Comments on #SDP-26-0003 - Planning & Zoning: Site Development Plan

Application Number: #SDP-26-0003
Application Type: Site Development Plan
Date: July 26, 2026
Address: 748 S MAIN ST, ROLESVILLE, NC 27571
Parcel: 1758465891

THIS DOCUMENT IS NOT AN APPROVAL.

C001

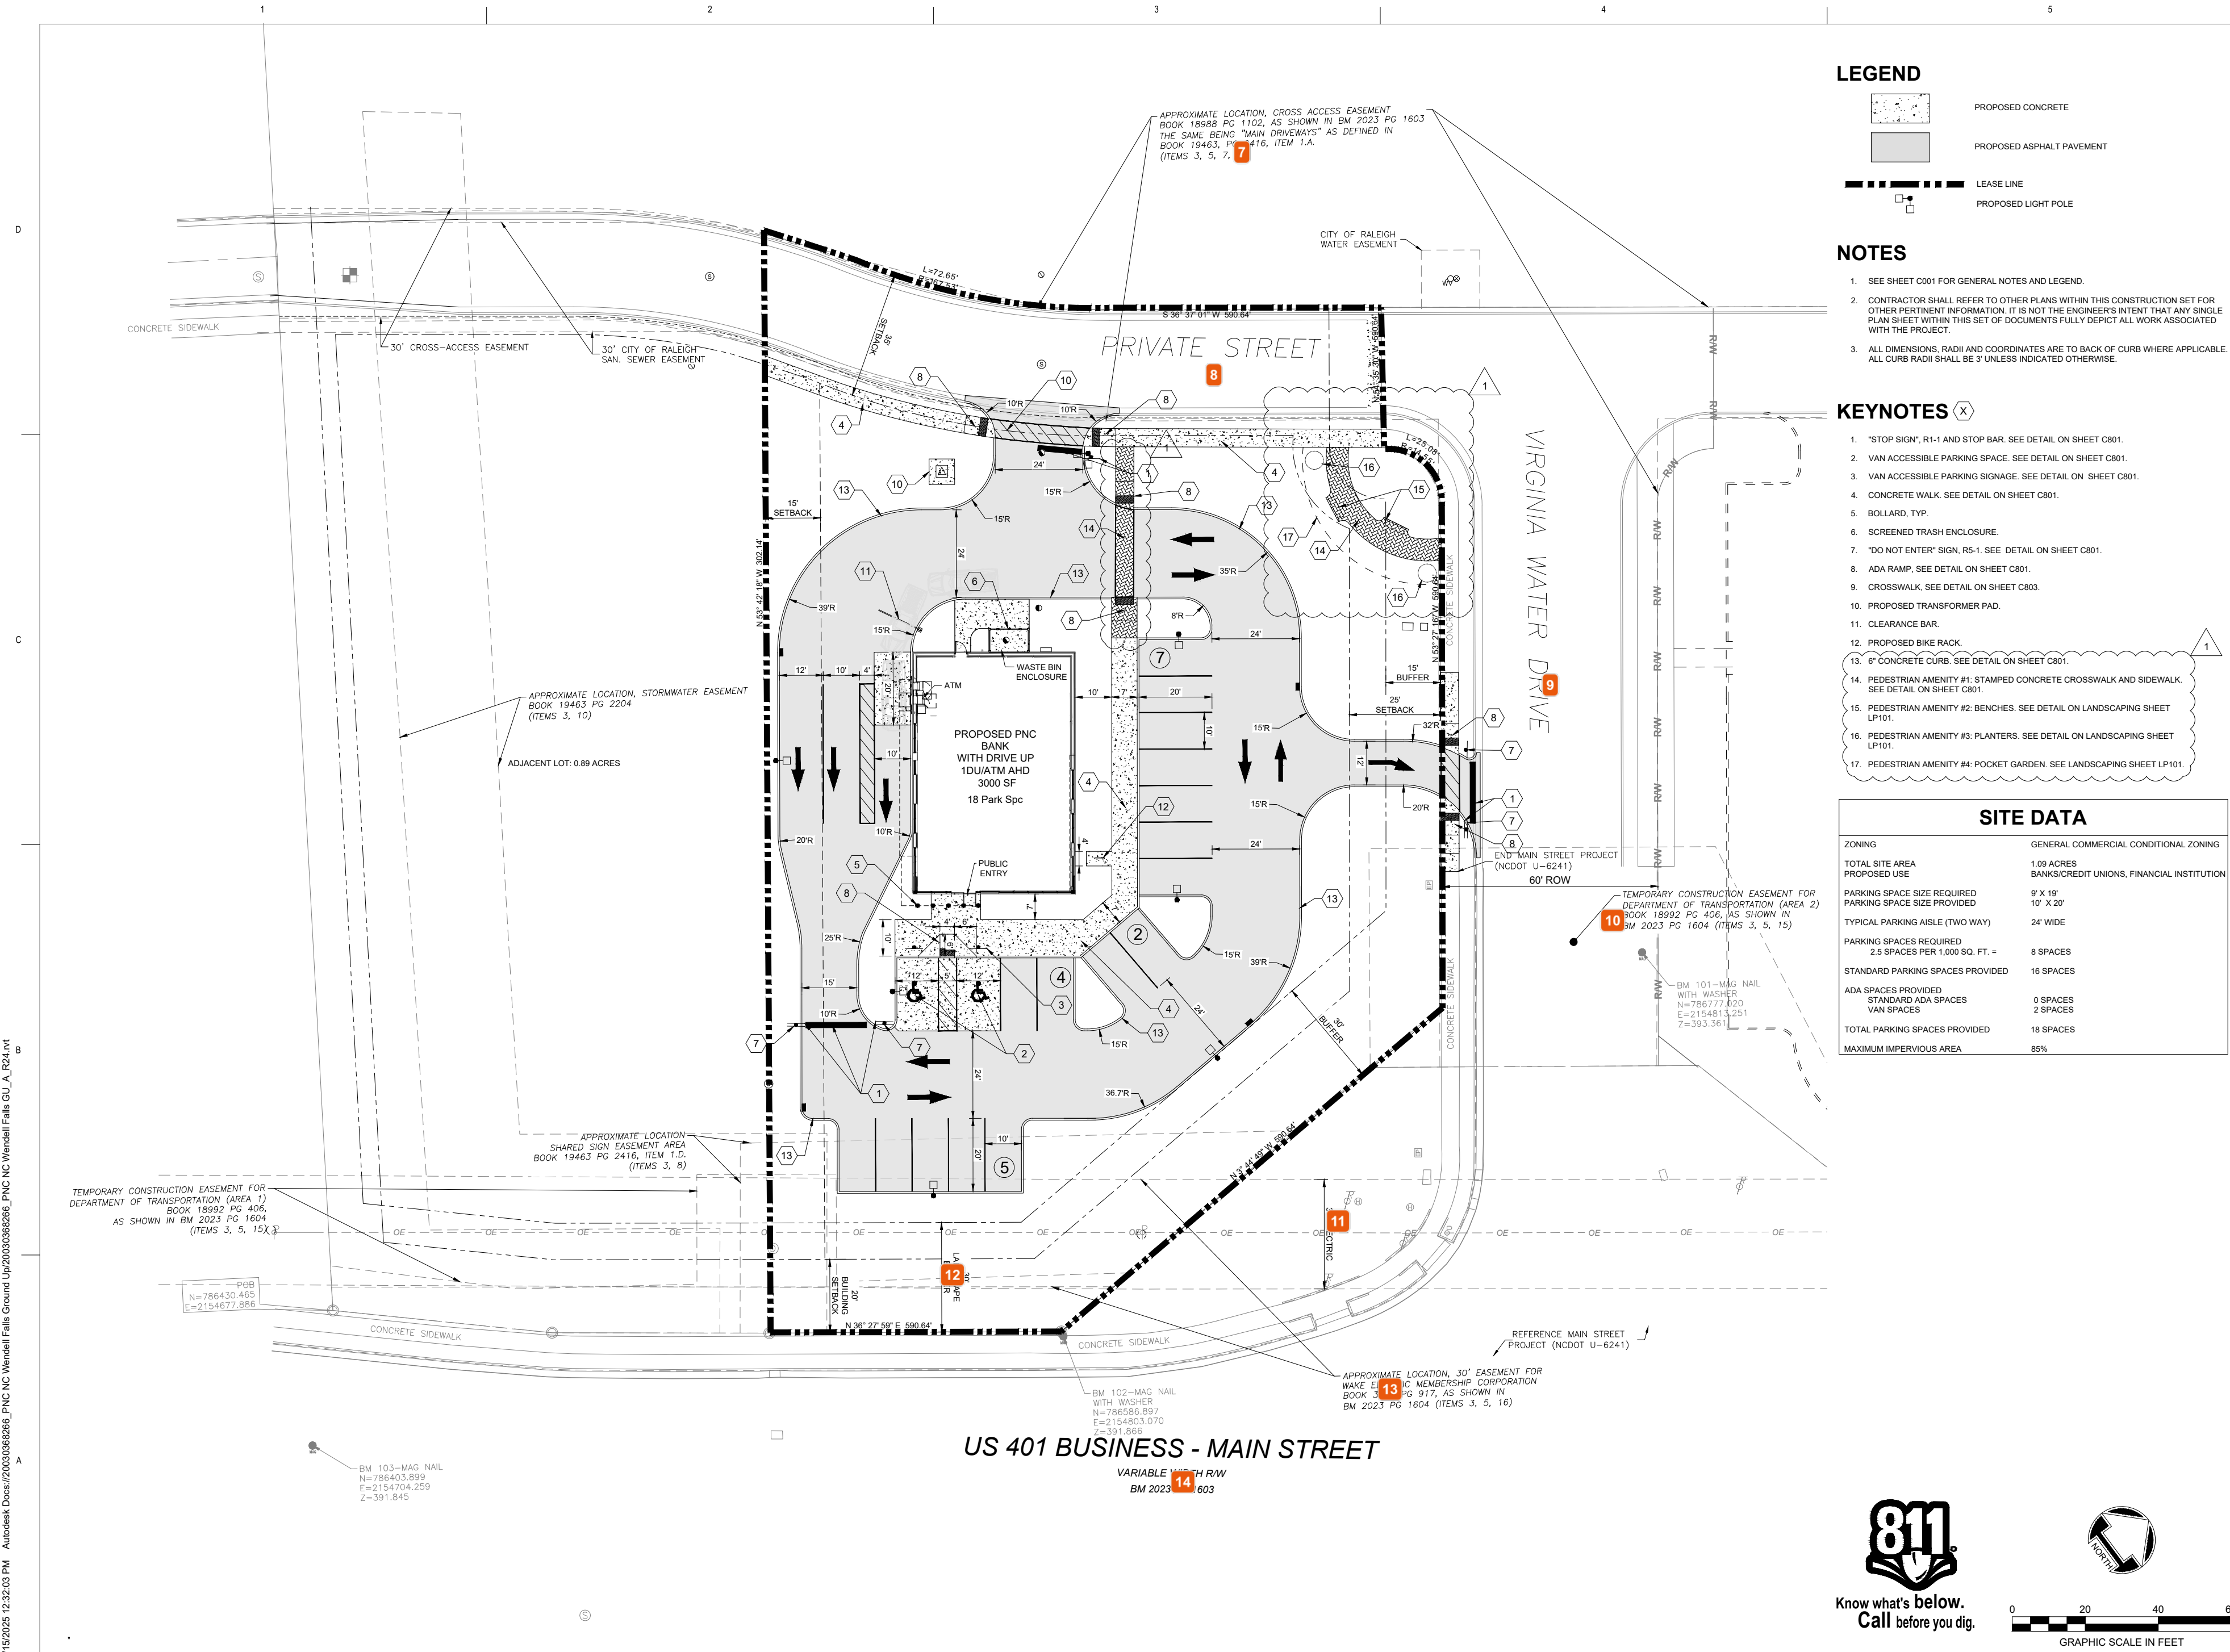
Can you please add "Site Development Plan" above PNC Bank. "Issued for Permit Review" does not really mesh with this plan set bc this is NOT a "Permit" per se. We reserve the term "Permit" for Building Permits and other "permits" like Signs, and not land development (Nor Subdivision).

I am not seeing a new review submitted to Energov for this review. Please reach out to me at Austin.bain@raleighnc.gov so we can get this squared away.

Add Energov to the coversheet for cross reference.

Check to see if this needs updated to reflect either/both property descriptions / property lines created in BM2026/pg1244.

REvise the Legal description to: LO9B WALLBROOK PARIS TR SUB BM2026 -01244 - this was just recorded (by the master developer) on 7/13/26.

Because this is a corner lot - can you add references for "FRONT" and "CORNER" - either Virginia Water or S. Main as those are the 2 street frontages and one of them is "Front" and the other would be the "corner". Do this by adding " - Virginia Water" at the end of the reference.

E601

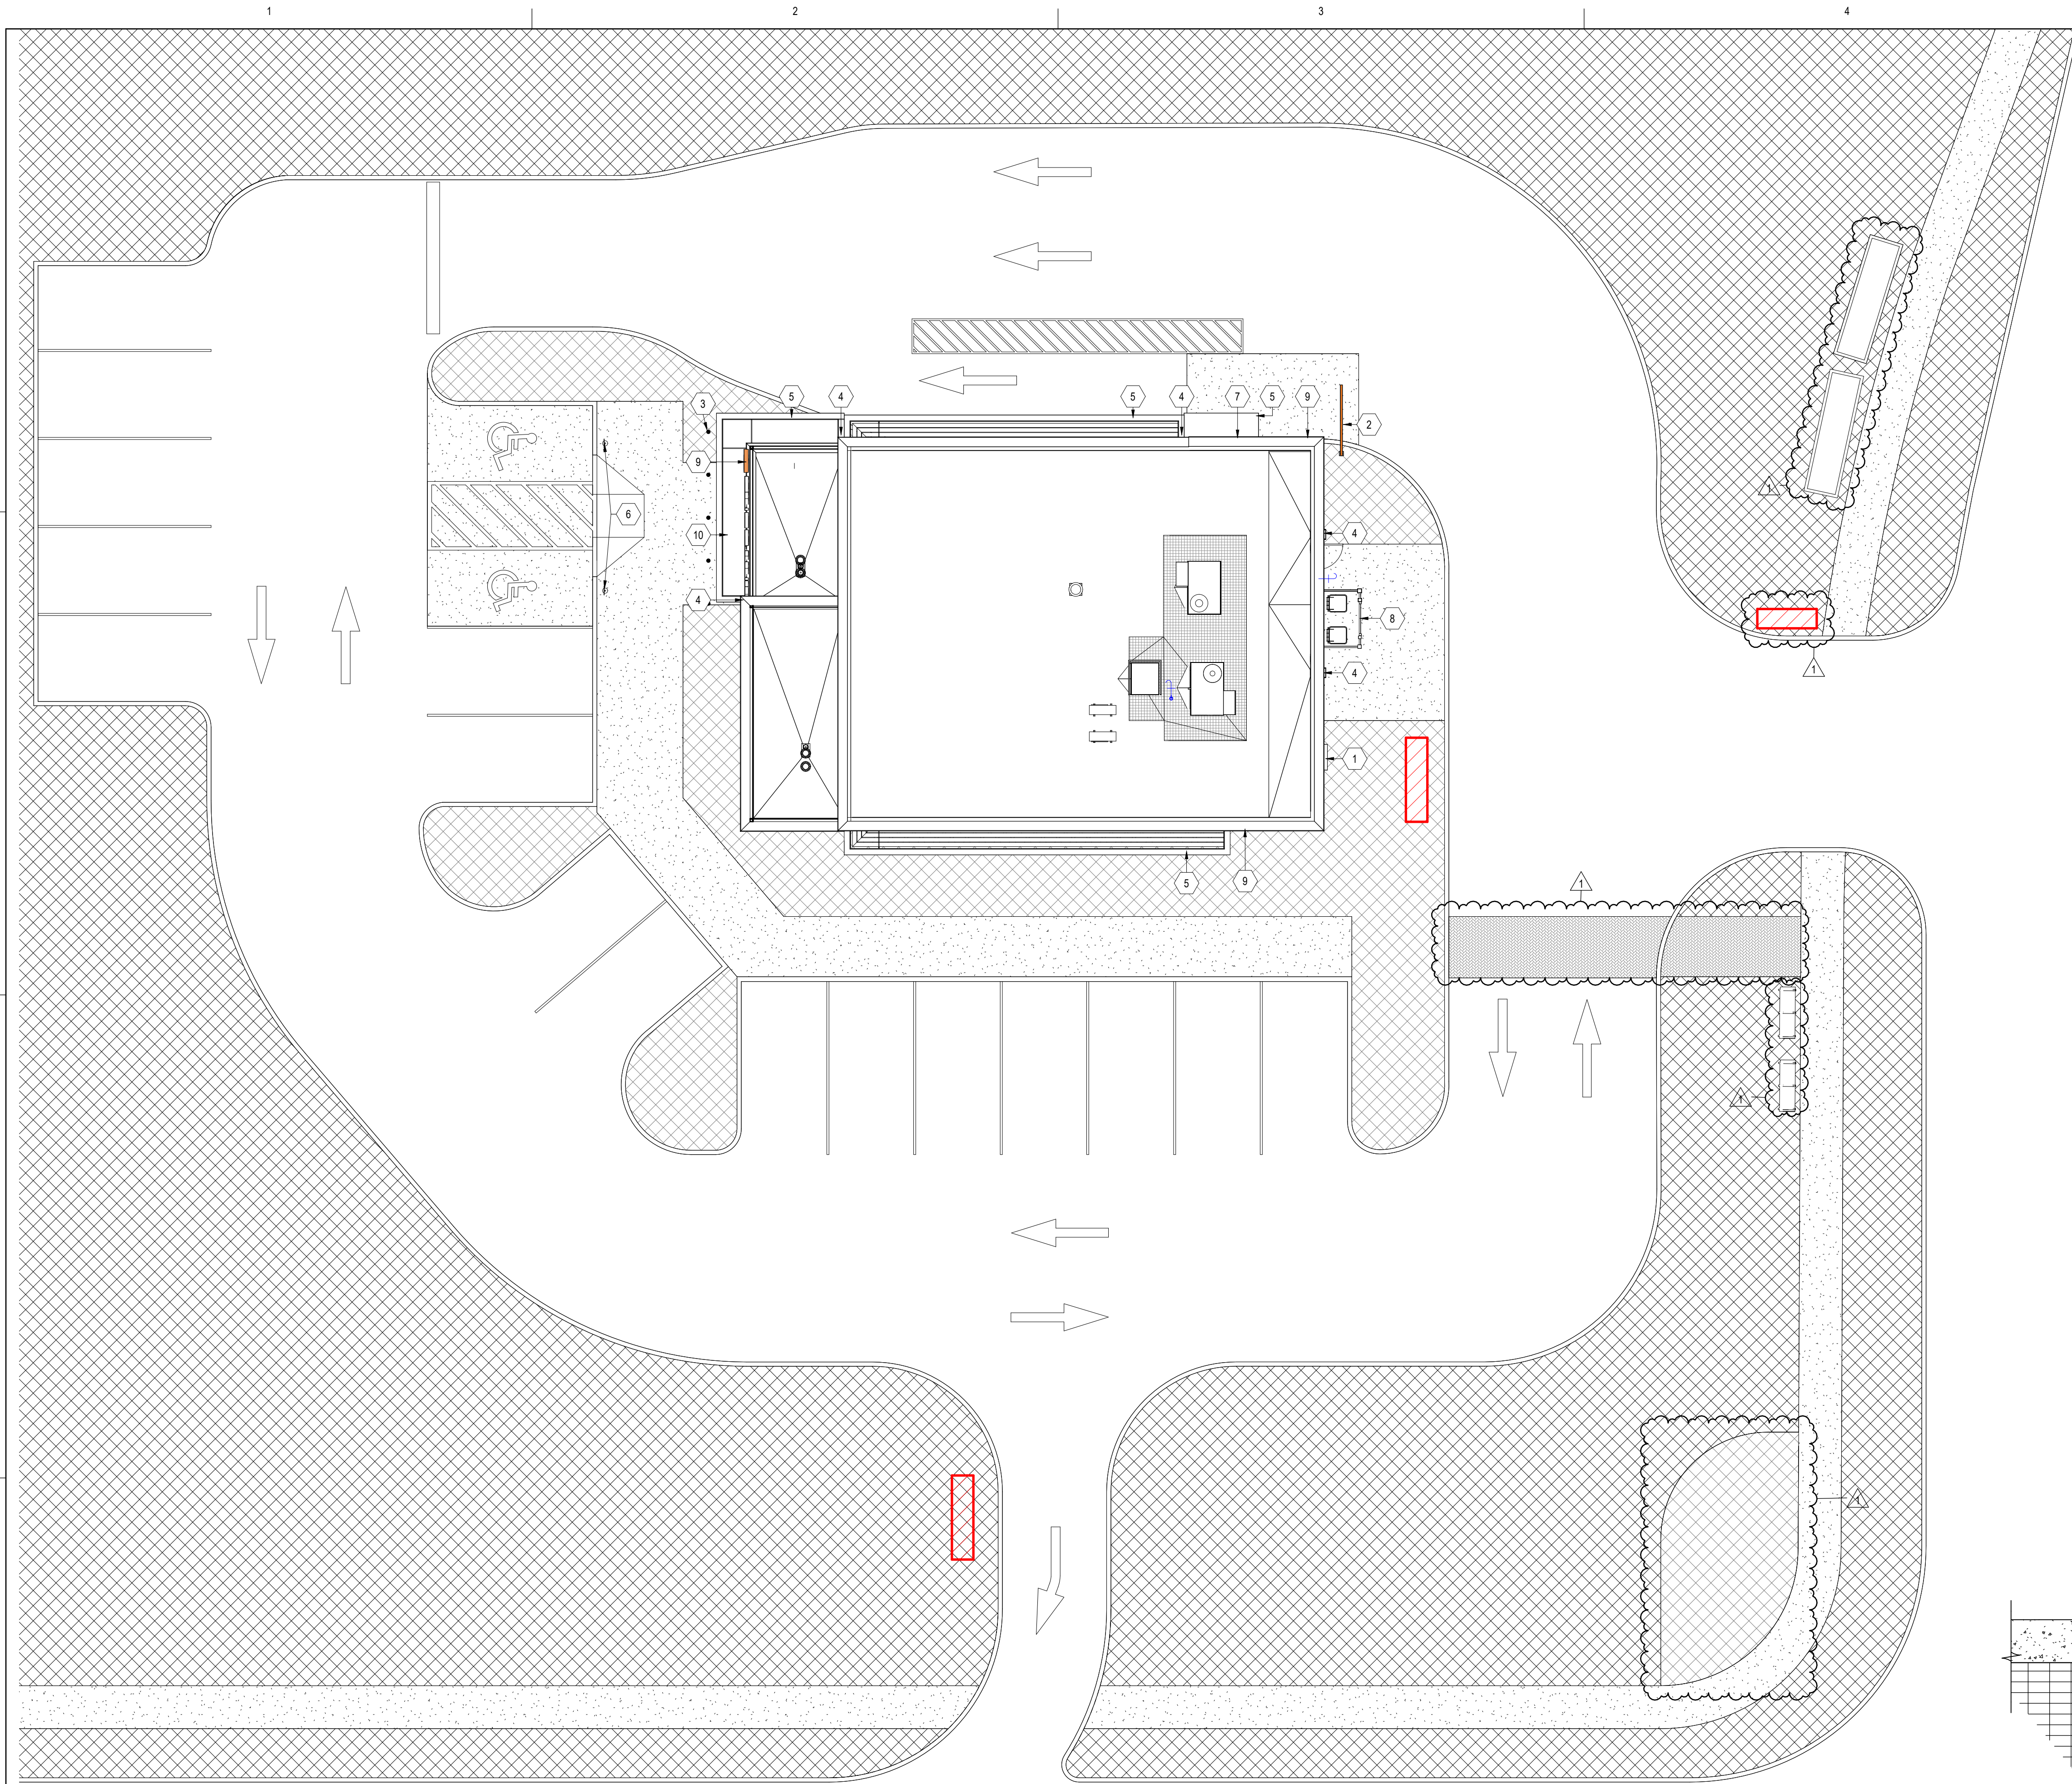
General note: Provide pole and light fixture details for wall and parking lot lighting.

General Comment: Confirm that the proposed site lighting will not conflict with proposed landscaping.

ARCHITECTURAL SITE PLAN

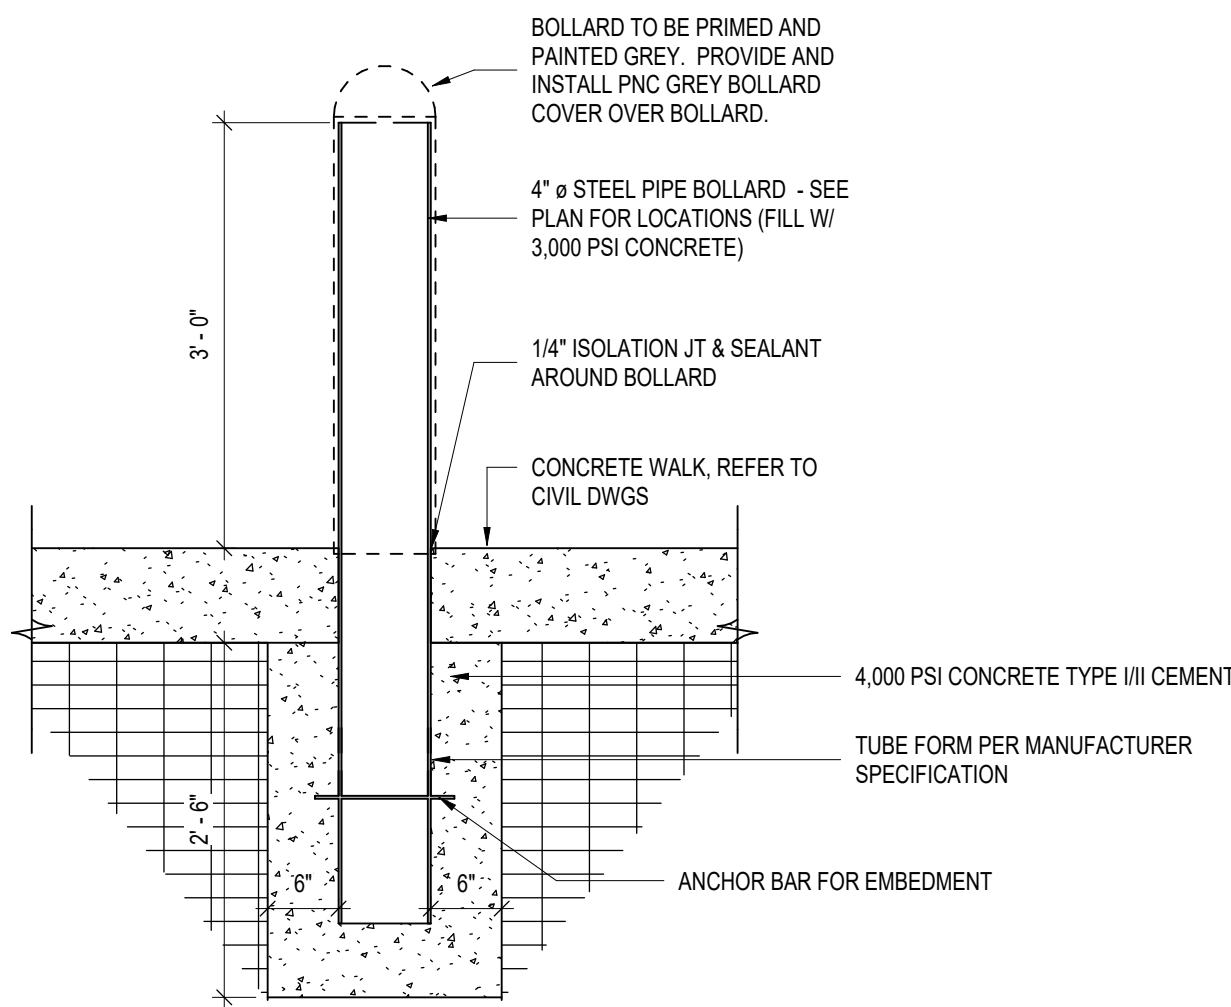
1. Add north arrow and label Va Water Drive
Label and north arrow added.

A1 EAST ELEVATION
SCALE: 1/4" = 1'-0"

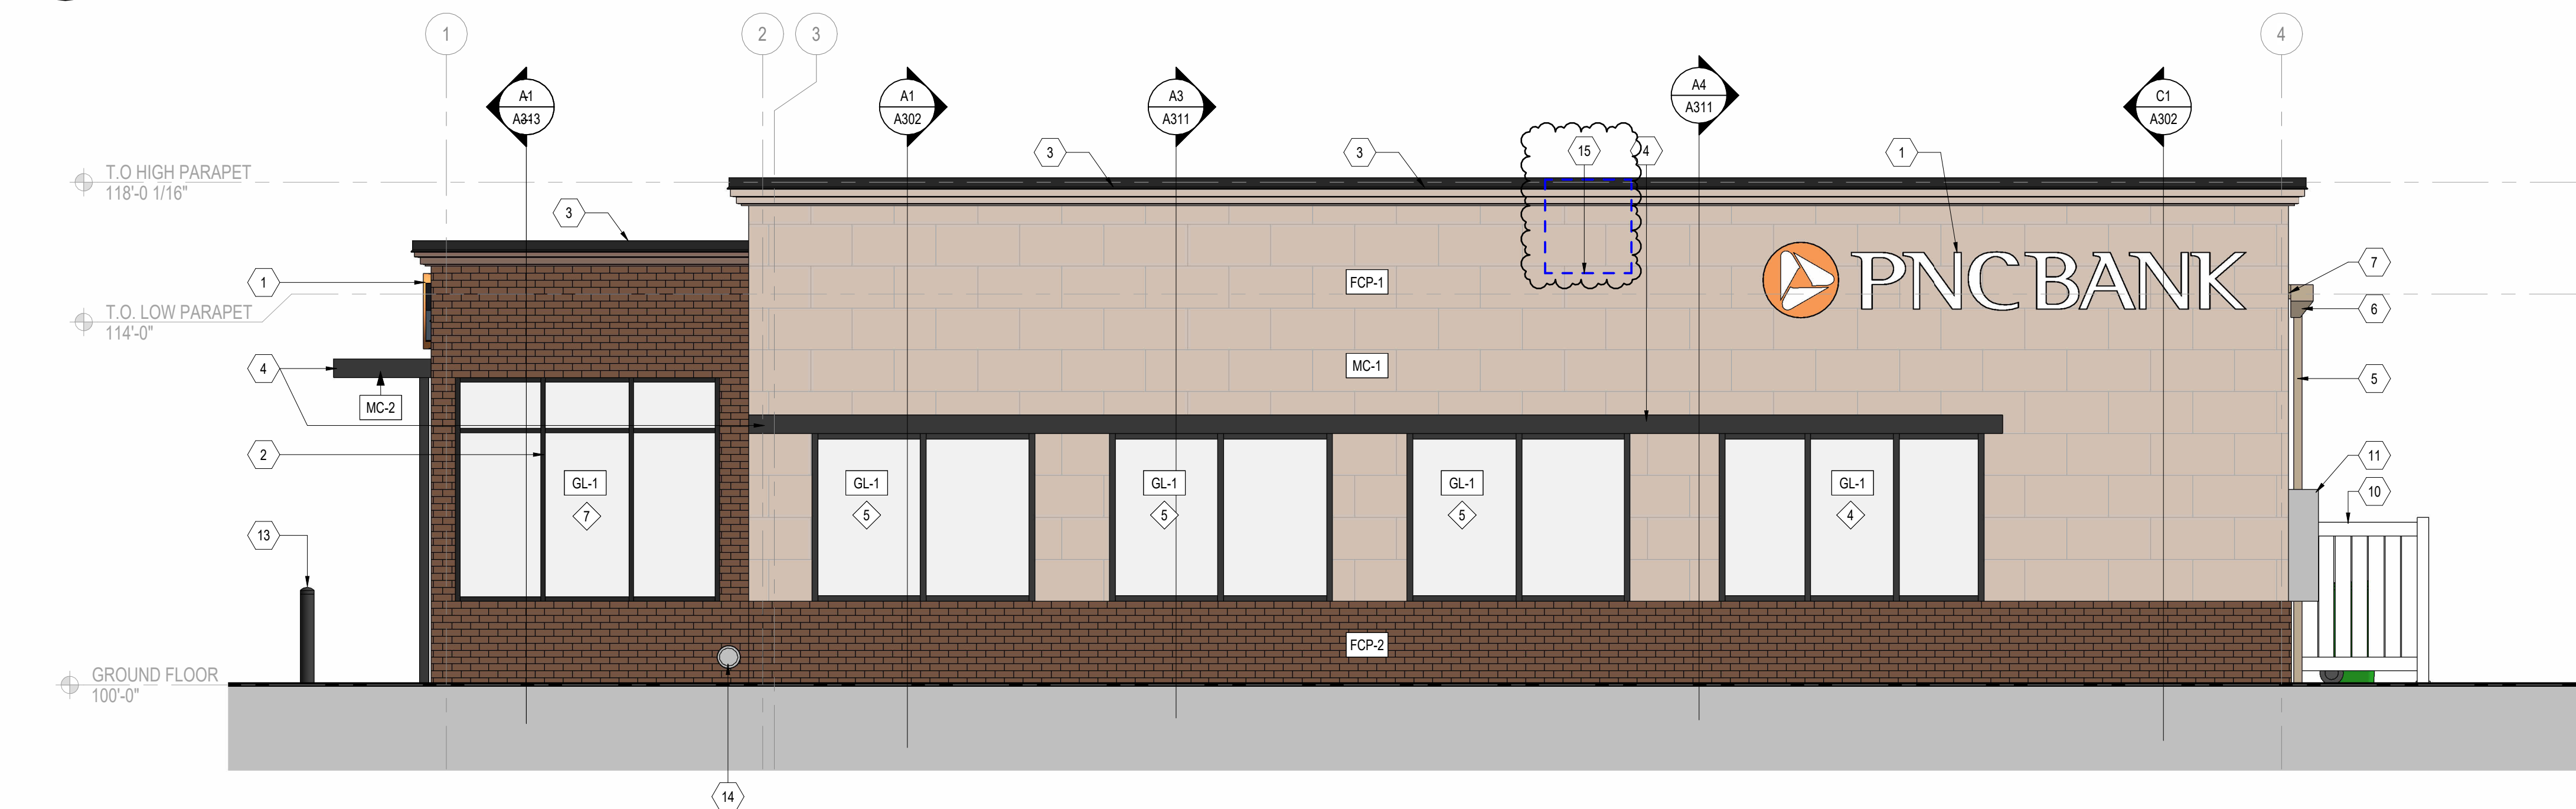
Provide pole height and light fixture details for wall and parking lot lighting in conformance with LDO, Section 6.6
